# CITY OF PORTLAND BUILDING PERMIT

PERMIT ID: 2012-50599

has permission to **Change of use to add dance & concert venue - install new fire door/landing & stairs** provided that the person or persons, firm or corporation accepting this permit shall comply with all of the provisions of the Statutes of Maine and of the Ordinances of the City of Portland regulating the construction, maintenance and use of the buildings and structures, and of the application on file in the department.

**Jeanie Bourke - RE: 250 Read St. plan review comments BP#2012-50599**

STAIR PROFILE  
& DIMENSIONS

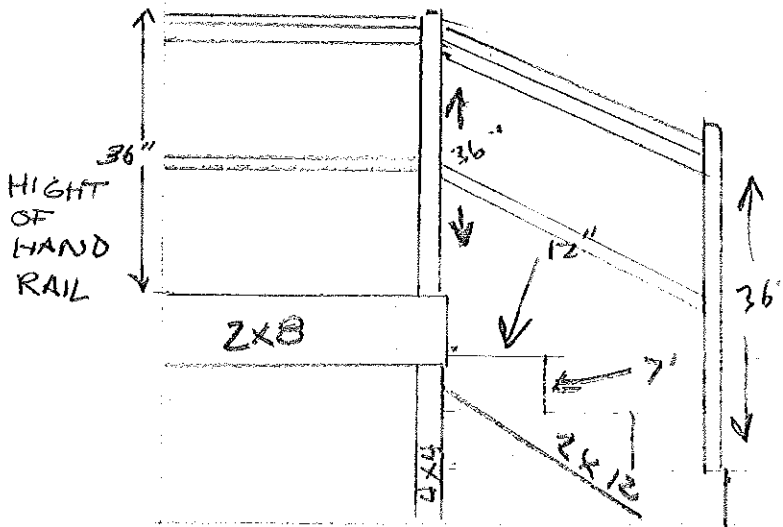
1. Clarify that a permit will be applied for at SFM, not just license app
2. Provide a concert seating diagram to scale or with aisle & spacing dimensions
3. Provide a layout or intention for the game room to justify the net 15 occupant load
4. Provide the area of the media room with calc for Business at 100 gross occ. Load
5. Provide a diagonal of the bldg. and the distance between the 2 egress doors
6. Provide life safety device location on plans
7. Confirm panic hardware to be installed on new door
8. Provide section of new ext. platform and steps with frost protection, attachments, bearing, stair profile & dimensions, and graspable handrail

8. Fred or the engineer will provide the details on the exterior stair and landing, which are also required by the SFM. Still awaiting these details.

NO NOSING ON STAIR TREAD

HANDRAIL DETAIL

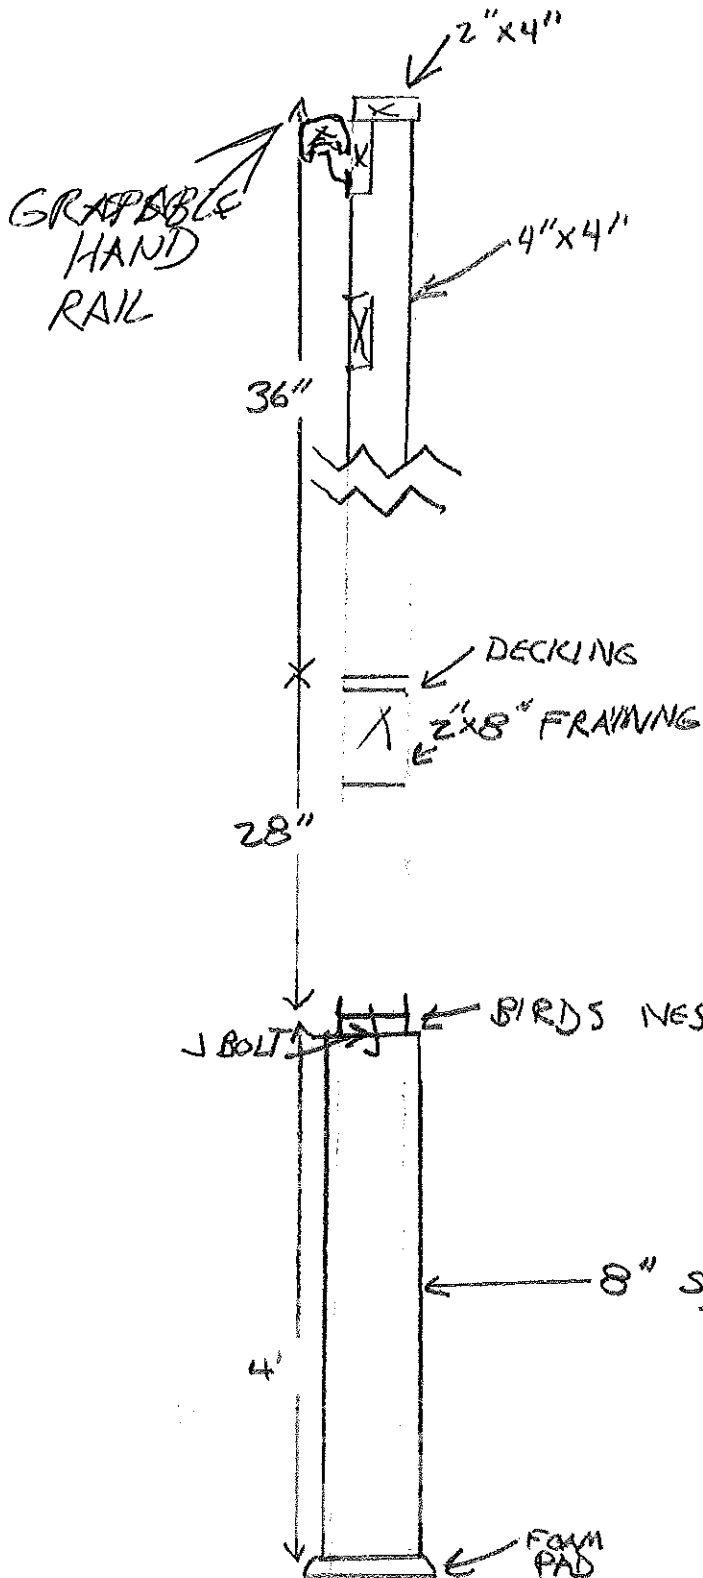
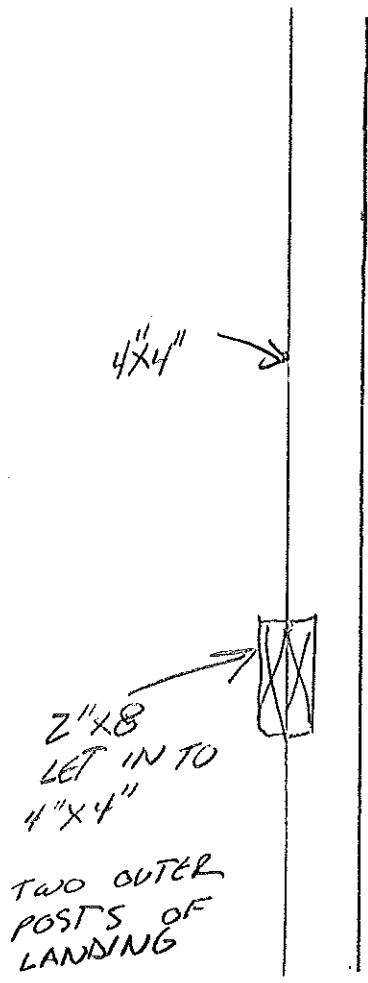
- 14) Notice: The first scheduled final inspection fee is at no charge. Additional inspections shall be billed at \$75 for each inspector.
- 15) Guards are required for the landings and stairs if they exceed 30 inches above the adjacent finished ground level.
